APPLICATION NO.	FILING DATE	FIRST NAMED INVENTOR	ATTORNEY DOCKET NO.	CONFIRMATION NO.
09/780,480	02/12/2001	Akira Senoo	Q62848	8117

DETAILED ACTION

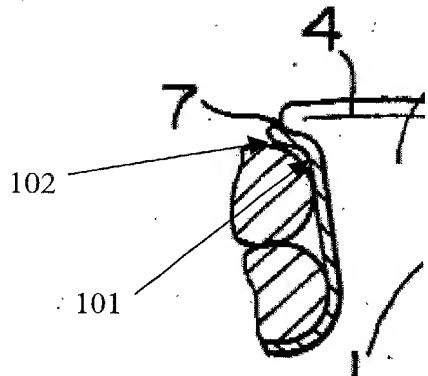
Honshima et al. clearly teaches the construction of an armature for an electric rotary machine, the armature comprising:

an armature core (2) provided with a plurality of slots (1) extending in an axial direction and disposed alongside each other in a circumferential direction;

an armature winding (3) inserted in the slots so as to be mounted on the armature core; and

an insulator (6) mounted in each of the slots wherein:

the insulator is disposed between an inner face of each slot and the armature winding (Figures 1, 2A, 2D, 4, 5A and 5B); and

first creases (101, added by the examiner) are formed on side portions of each insulator so as to extend in a lengthwise direction of the slot at a slot-opening end of the side portions, the first creases being formed by first bent parts for angling the slot-opening ends of the side portions so as to be apart from each other.

4. With regards to claim 11, Honshima et al. disclose second creases (102, added by the examiner) are formed on the side portions of each insulator so as to extend in a lengthwise direction of the slot at a location closer to the slot-opening end than the first creases, the second creases being formed by second bent parts for angling the slot-opening ends of the side portions toward each other.
5. With regards to claim 13, Honshima et al. disclose the side portion of each insulator expand in a circumferential direction at the bottom ends of the side portions of the insulator, thereby coming into close contact with inner faces of the slot toward the bottom thereof as shown in Figures 1, 2A, 2D, 4, 5A and 5B.
